## MEMORANDUM

RE: **USEPA Comments and Responses**  
**PCC-Validation Site**  
**Pontiac, Michigan**

HOLE DESIGNATION: MW92S-13

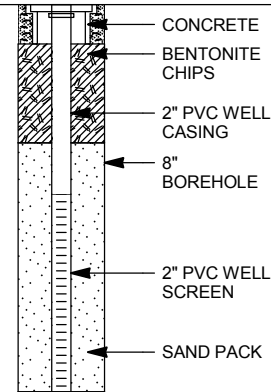
*Can you have CRA transmit the boring logs for MW92S/I-13 and MW93-13? I didn't see these included in either the CA725 or CA750 reports.*

The boring logs for MW92S/I-13 and MW93-13 were included in Appendix B of the addendum to the EI CA750. Additionally, they are attached to this response for your use.

PROPOSED WELLS FOR MONITORING AND/OR ABANDONMENT

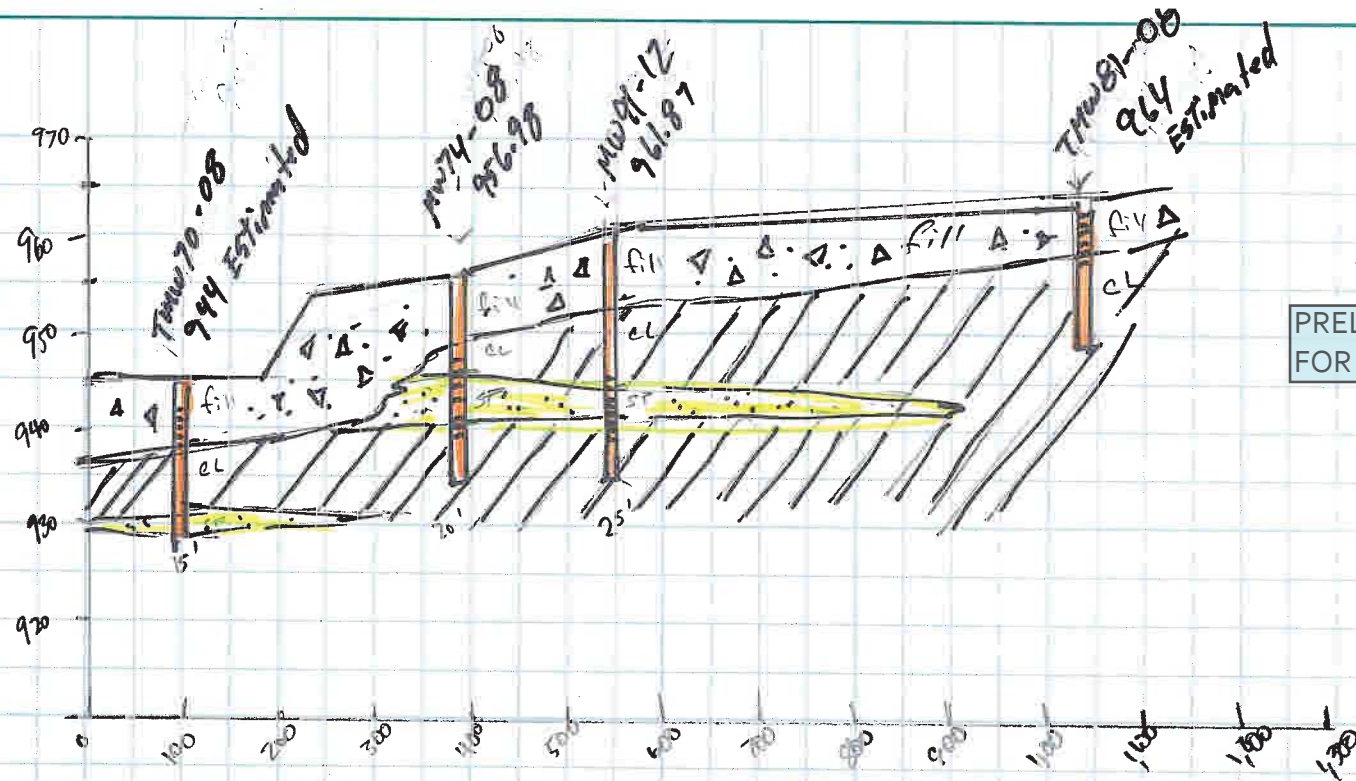
*With respect to the wells proposed for abandonment, I would propose that you keep MW10-07 and MW21-07 as they are perimeter wells along the side of the facility adjacent to a residential community. Propose keeping MW79-12 as an upgradient "boundary" well for the organic contamination in the area.*

Per your request, the three wells will not be abandoned as identified in the updated Figure 1. Upon approval, the indicated remaining monitoring wells will be abandoned.
